Denial

Subject: Mine Ventilation Plan, Section 75.370, 30 CFR, Upper Big Branch Mine-South, I.D. No. 46-08436, Performance Coal Company, Montcoal, Raleigh County, West Virginia

Ventilation Plan

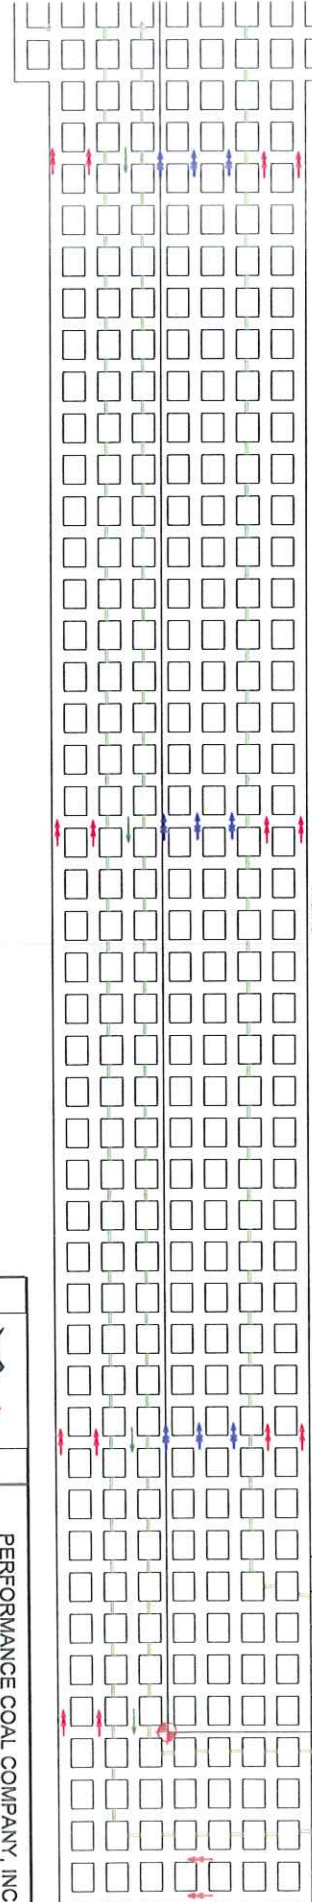
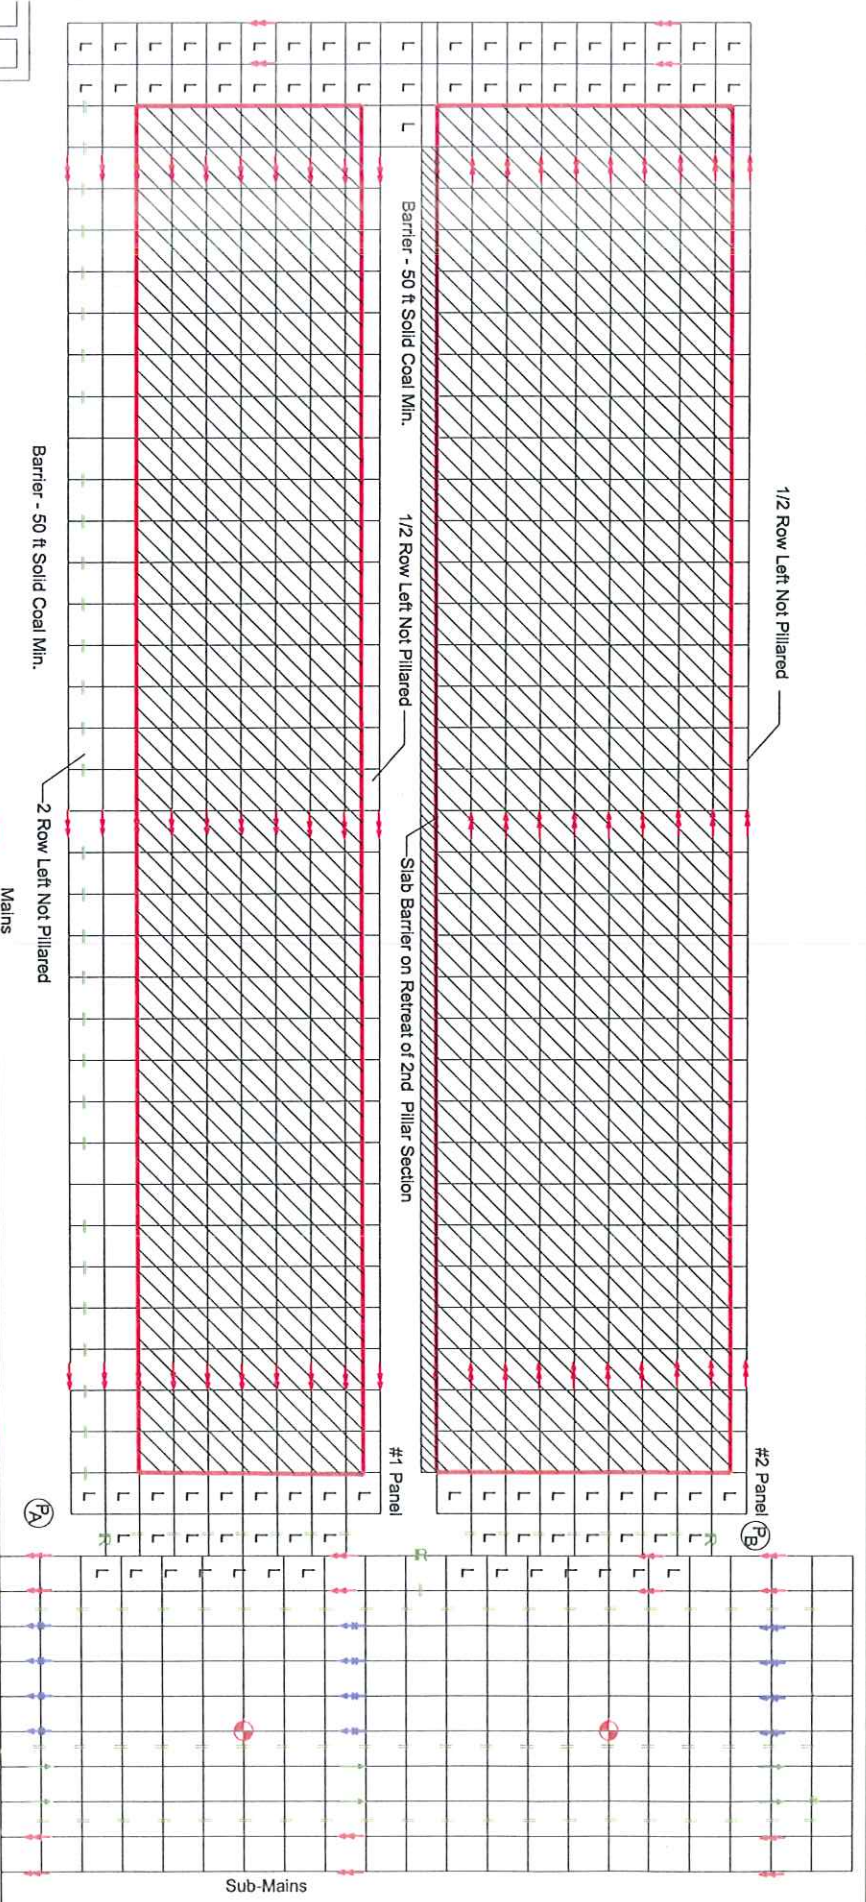
- *Two safe Truolways will be maintained to the bleeder Evaluations Check Points*
- *Water will not be allowed to Accumulate and Block or obstruct bleeder flow*

All previous ~~Developed~~ Panels Pillared & Entered the Last Panel Developed

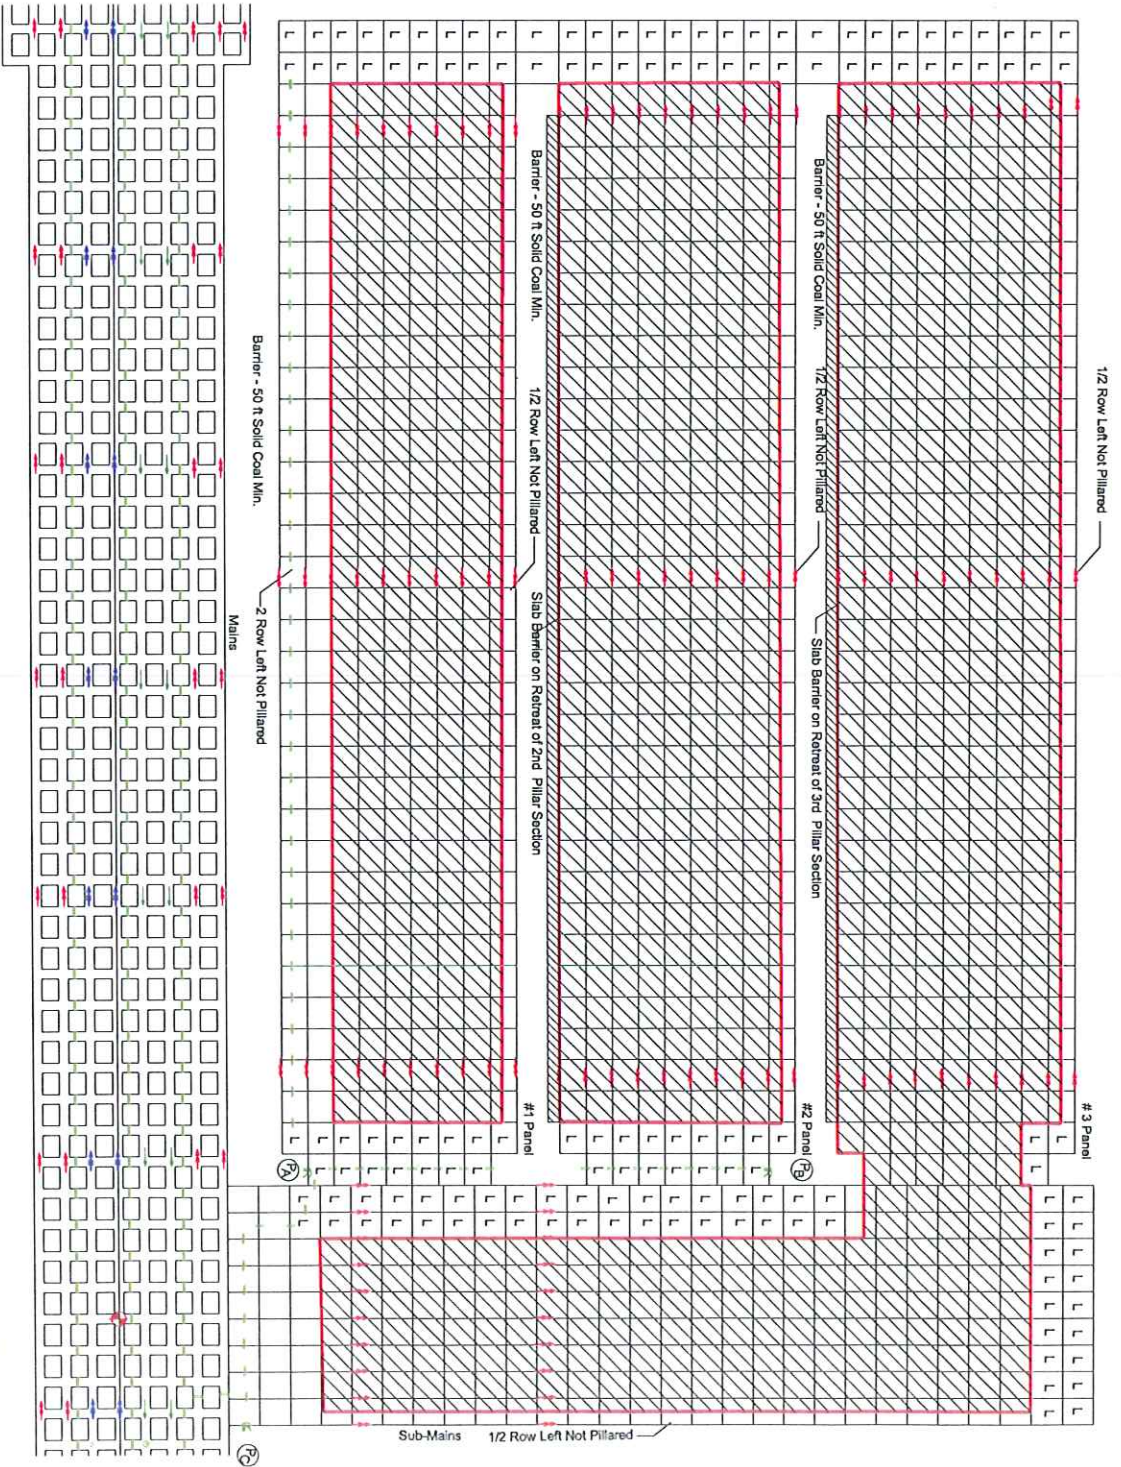
- One half row of blocks will be left on the solid side to better facilitate air flow in the gob area.
- While the sub-mains are being pillared, the bleeder will be evaluated (weekly) at the bleeder evaluation points outby. *bleeder evaluated at P-A, P-B + Piller line*

- The sub-mains pillar line will be stopped (as shown on drawing 6) one row in by the first panels bleeder evaluation point. A set of bleeder controls will be built across the sub-mains as shown on drawing 6. *Remove*

- *Two SAFE TRAVELWAYS will be maintained to the bleeder Evaluations check Points.*
- *Water will not be allowed to Accumulate and block or obstruct bleeder Flow*

PERFORMANCE COAL COMPANY, INC. P.O. BOX 66, NACOMA, WV 25140	
UPPER BIG BRANCH MINE		M.S.H.A. ID No. 46-08436 WV ID No. U-3042-02	
PREPARED BY 		Date: 04/27/09 SCALE: 1"=200' DRAWN BY: RL - 3 Staff CHECKED BY:	
External Bleeder System Utilizing Punchouts (Drawing 7)		VENTILATION BASE PLAN

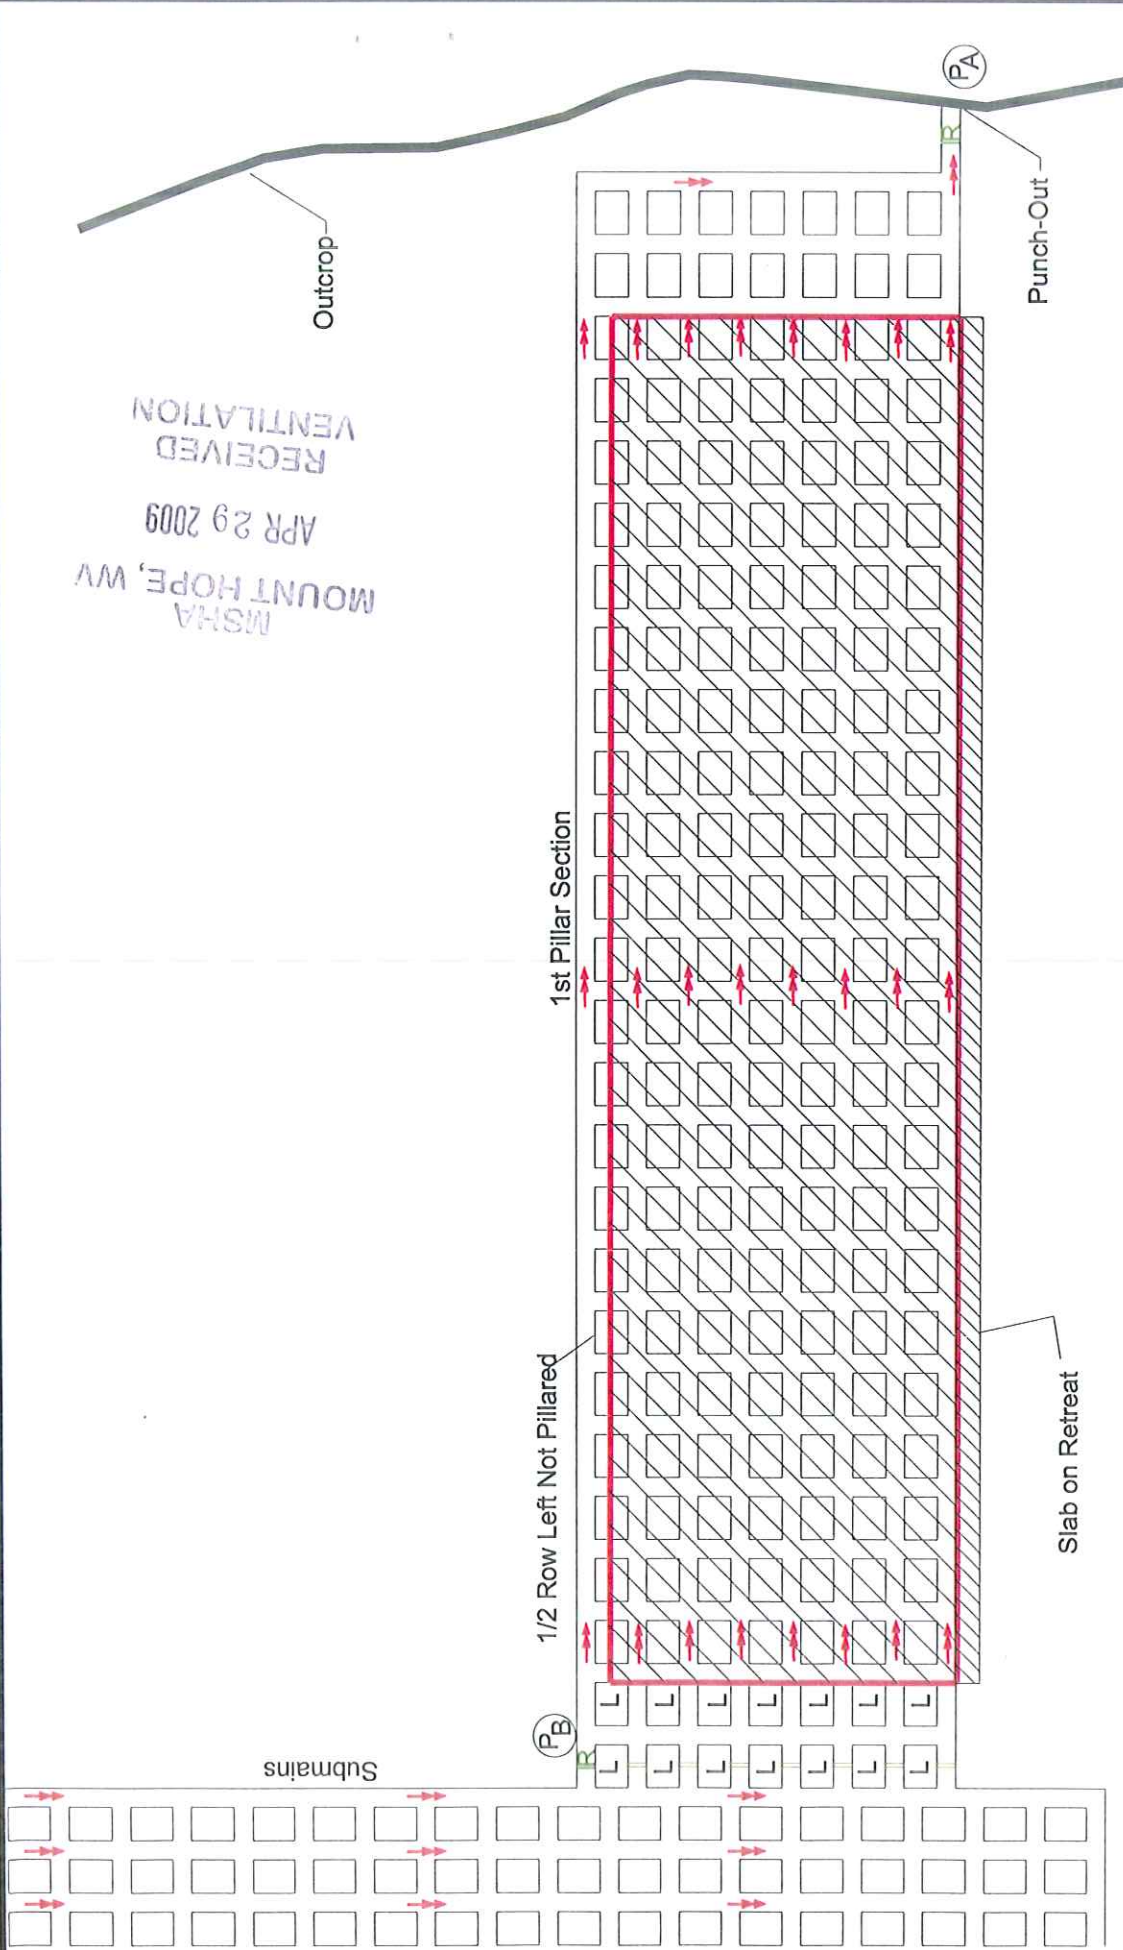
- Once this section has been completely pillared, the bleeder controls at the mouth of the section will be built as typically shown on Drawing 7. Controls to be plastered on pressure side. *Remove*

Water will not be allowed to accumulate to block or obstruct Bleeder Flow.

External Bleeder System Utilizing Punchouts
For Multiple Pillar Sections of Various Length
(Drawing 8)

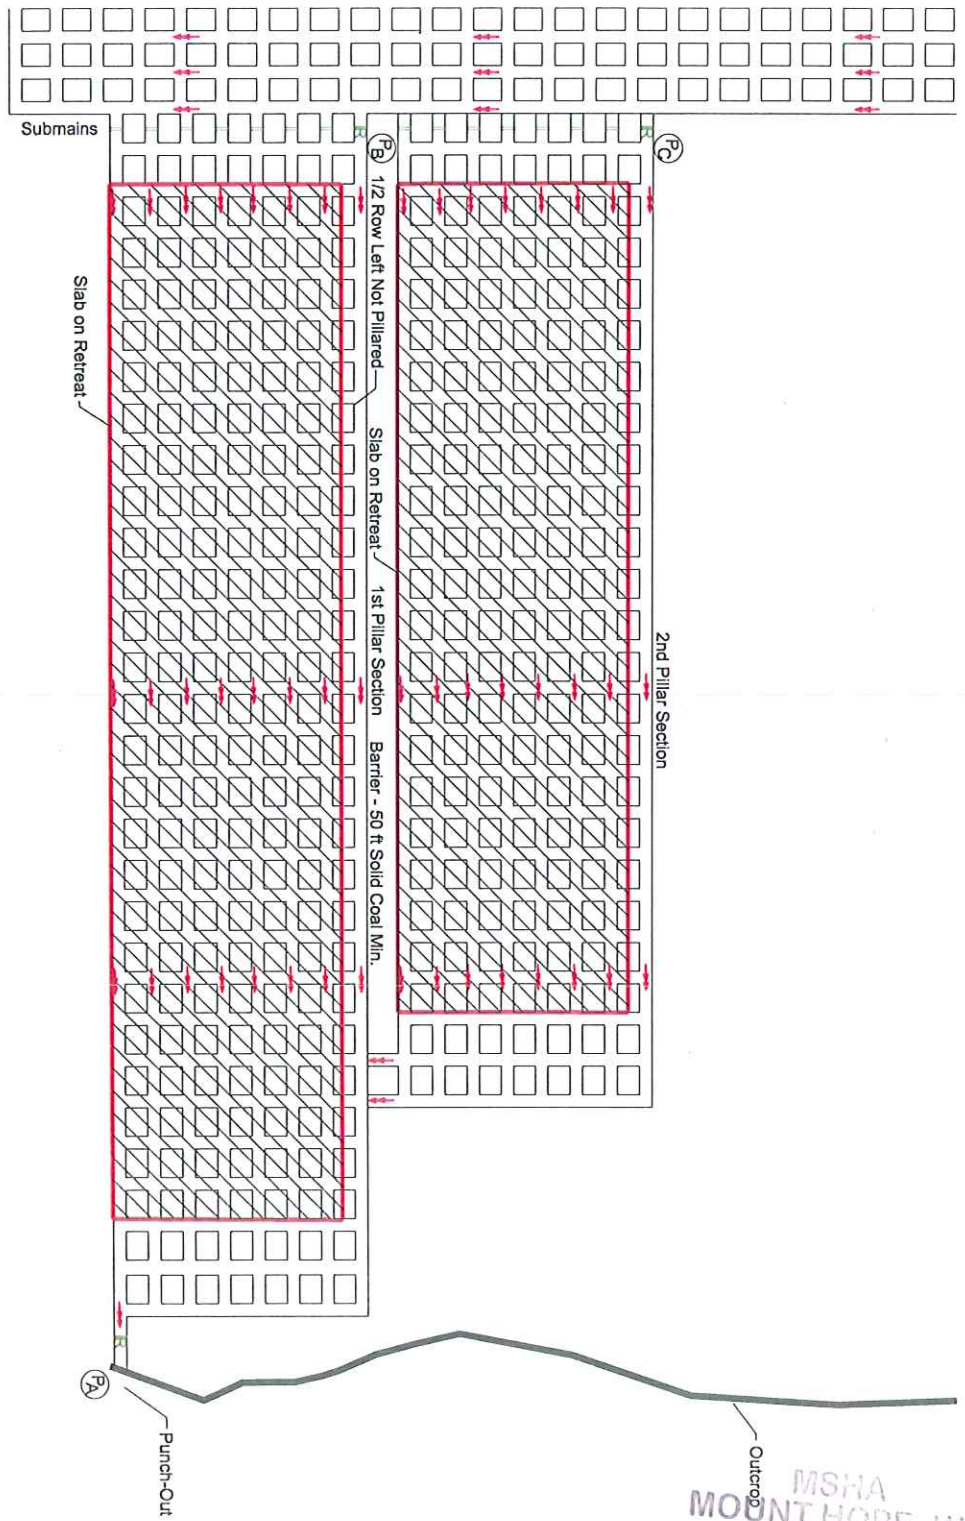
*WATER will not be allowed to accumulate
And block or obstruct Bleeder Flow.*

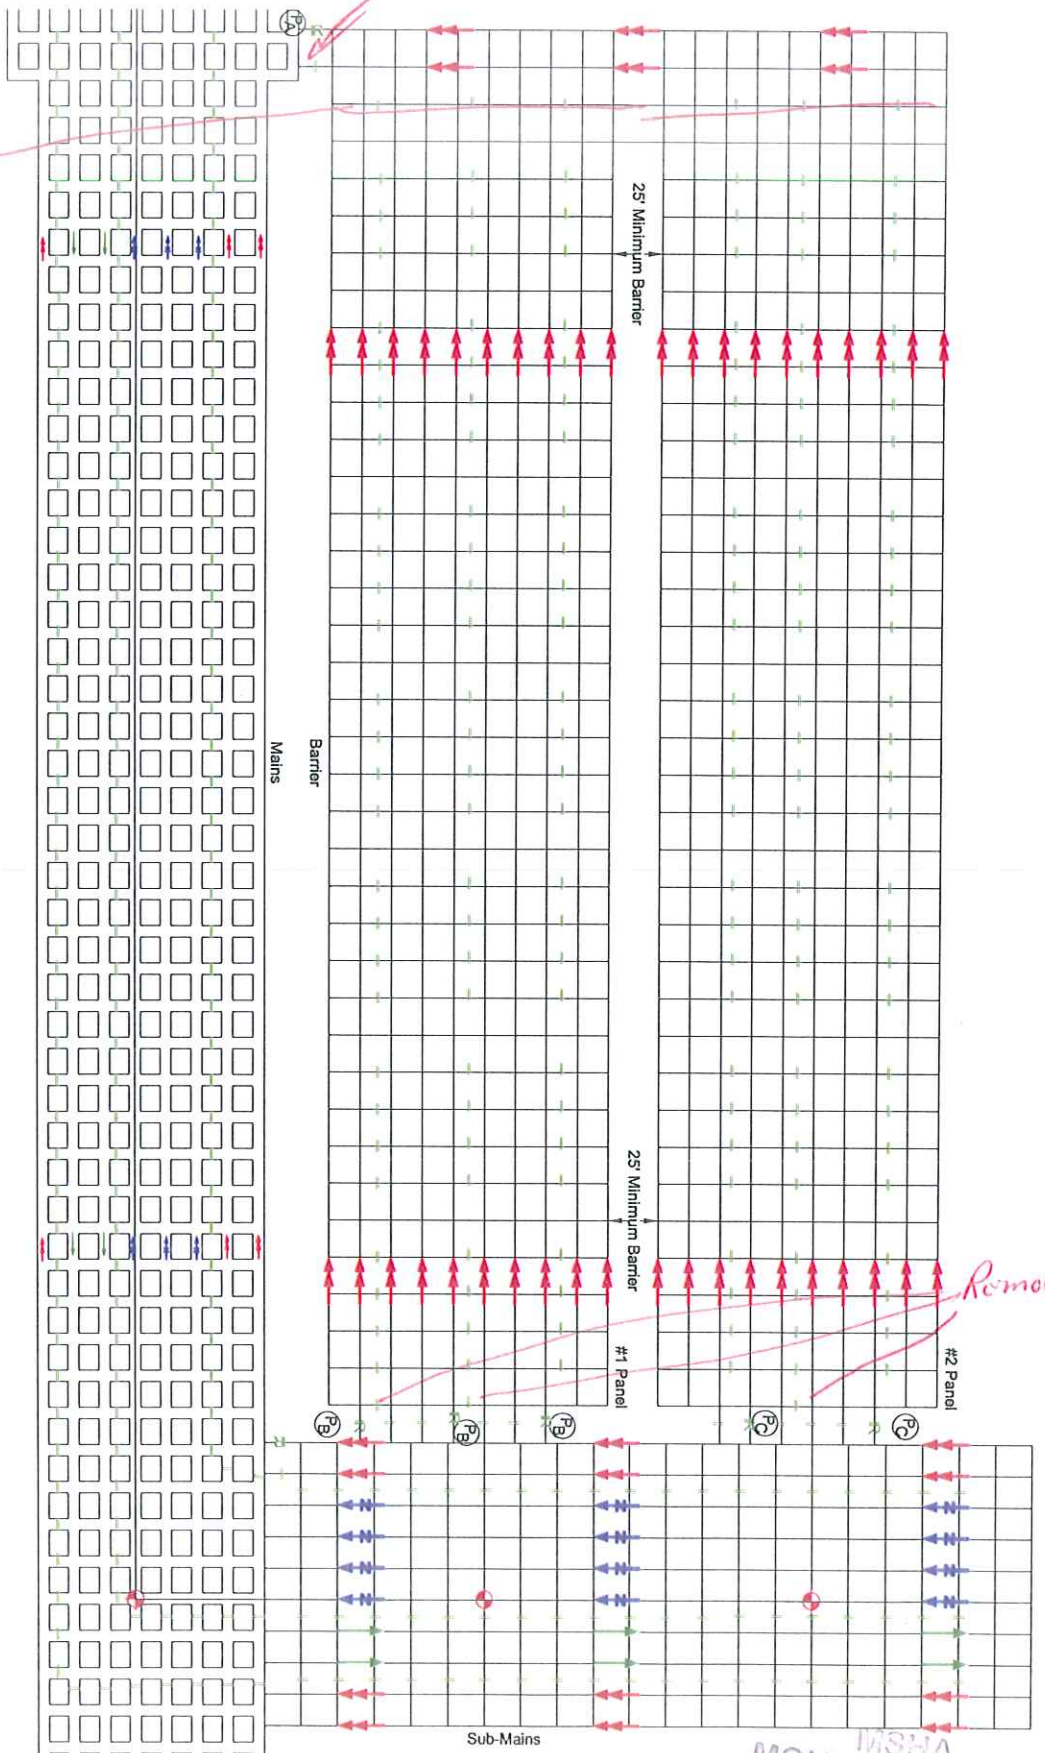
- Bleeder controls will be installed typically as shown at P-A, P-B, and P-C. All permanent ventilation controls will be plastered. *Remove*
- Evaluation points will be established at P-A, P-B, and P-C for weekly evaluations.

Remove

Water will not be allowed to accumulate and block or obstruct bleeder flow

Stoppings, as shown in the drawings, will be removed at least every 600' in the first & sequential panels to make the ventricies common when the evaluation points are established.

Show controls
 Across back of
 Panels & EPS

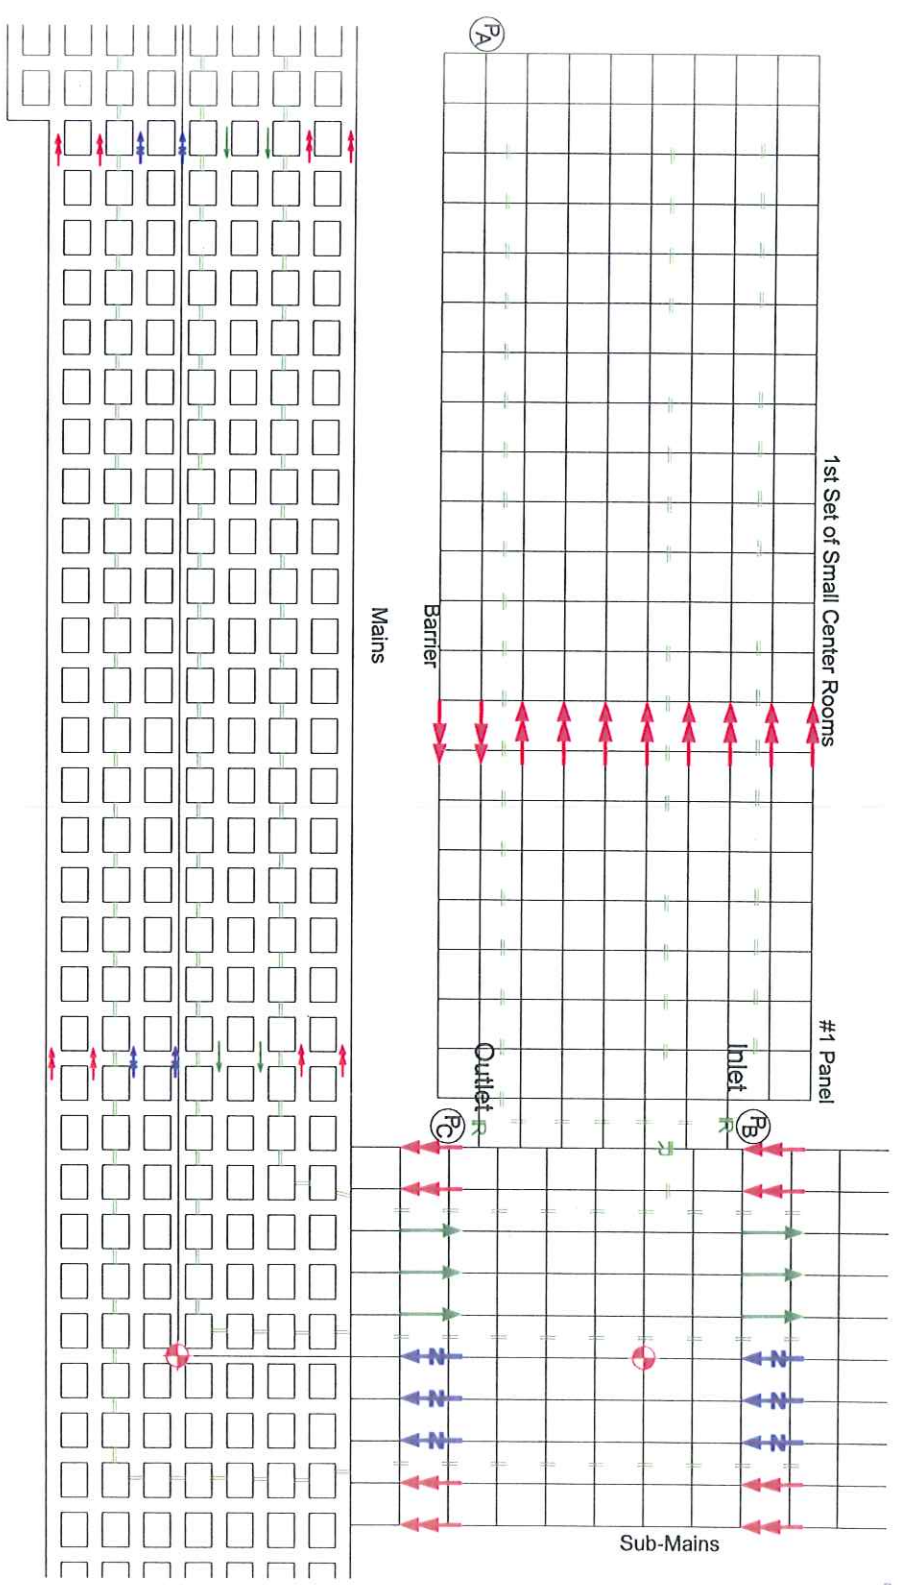
- Two safe Travelways will be maintained TO THE bleeder EVALUATION check point.
- WATER will not be allowed TO accumulate AND Block or obstruct bleeder Flow
